**Subject: Draft CERC (Indian Electricity Grid Code) (Fifth amendment) Regulations, 2016- Regarding**

**Comments of CEA on CERC (Indian Electricity Grid Code) (5th Amendment) Regulations, 2016**

**Subject: Scheduling procedure for un-requisitioned power**

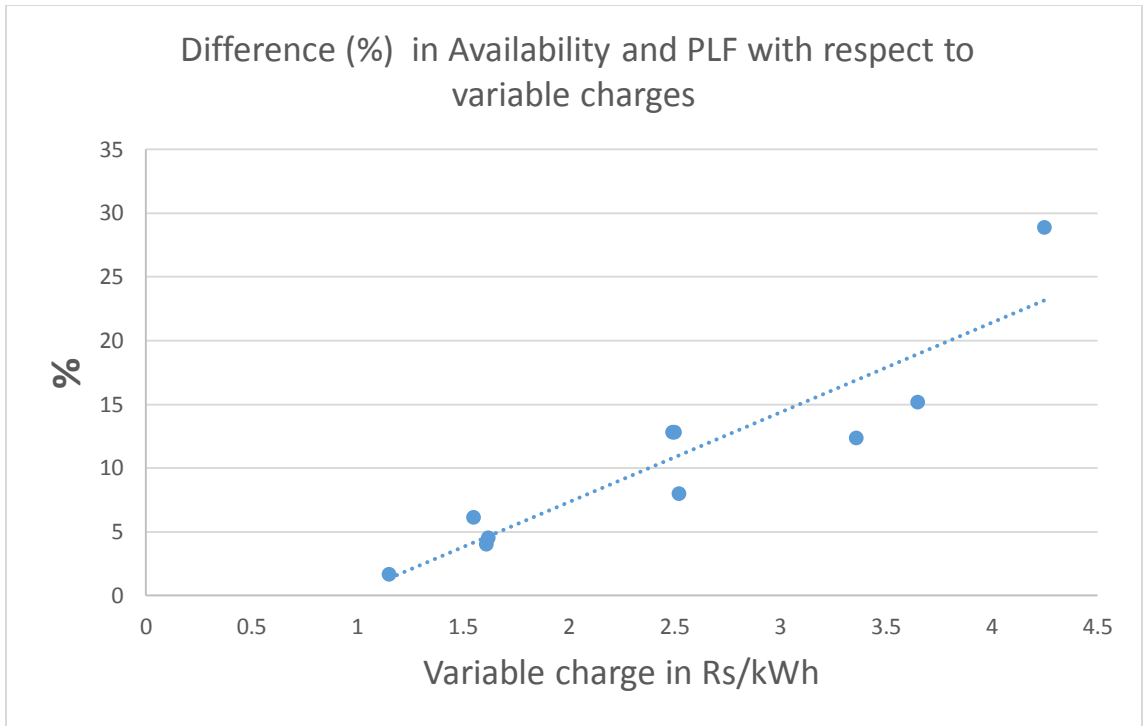
1. It is to state that the quantum of URS which is existing, is small compared to total power scheduled from central sector generating stations. Also major part of URS is existing in costly stations which is not being scheduled by beneficiaries due to high variable cost. The price of such power is not competitive to make it attractive or saleable in power market. So for this, making a procedure by amending all existing scheduling procedures, timelines which not only require changes in regulatory regime but also has potential of disturbing corridor allocation time lines and power market price discovery, does not appear appropriate. The existing one-day advance scheduling procedure is based on Availability based tariff and Grid code since the year 2000, and just for harnessing small quantum of URS, it may not be appropriate to amend this procedure without consulting all stakeholders. As an estimate, only 1.5 % URS would be available at pit head stations and majority is available at high variable cost plants like Mauda and Jhajjar. Other than this, URS is available at gas based stations due to its high cost and it cannot be sold in the Power Exchange even at Variable cost. It may also be mentioned that major part of the URS is available during off peak hours.

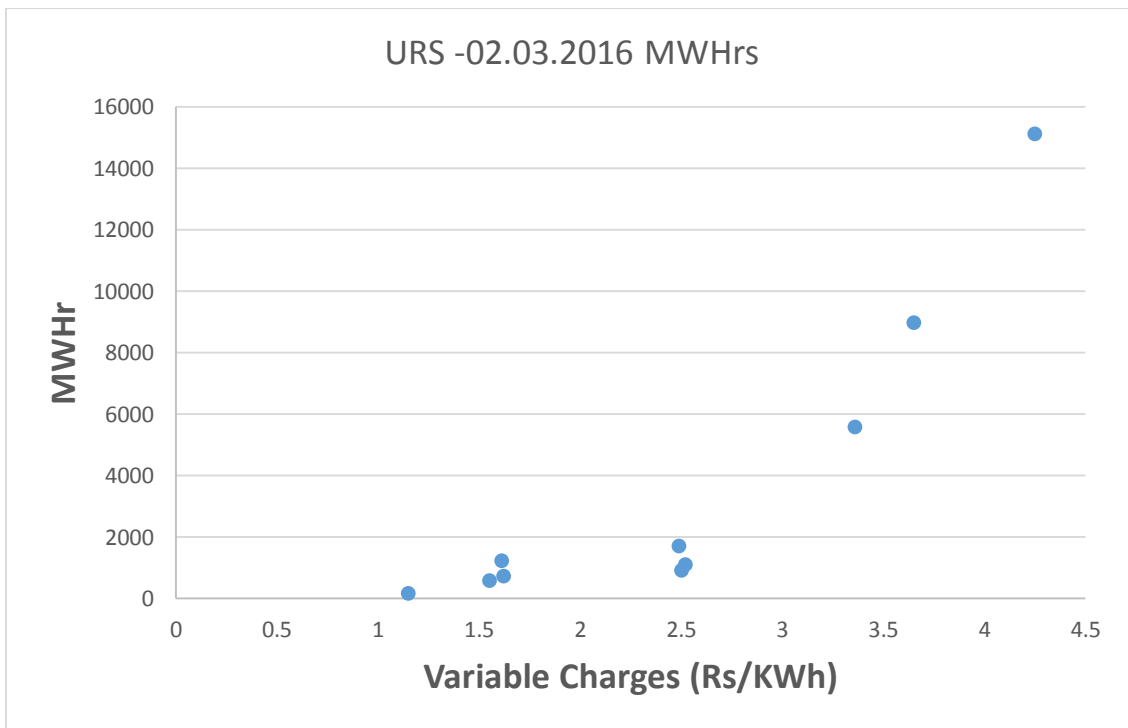
2. An analysis of Regional Energy Accounts of Northern Region in respect of Central Sector generating stations for the year 2014-15 shows that the possible quantum of URS i.e difference between Declared availability and Plant load factor achieved is directly correlated with the variable cost of the generating stations.

3. Also URS available in NR for 2.3.2016 is having a direct correlation with Variable charges
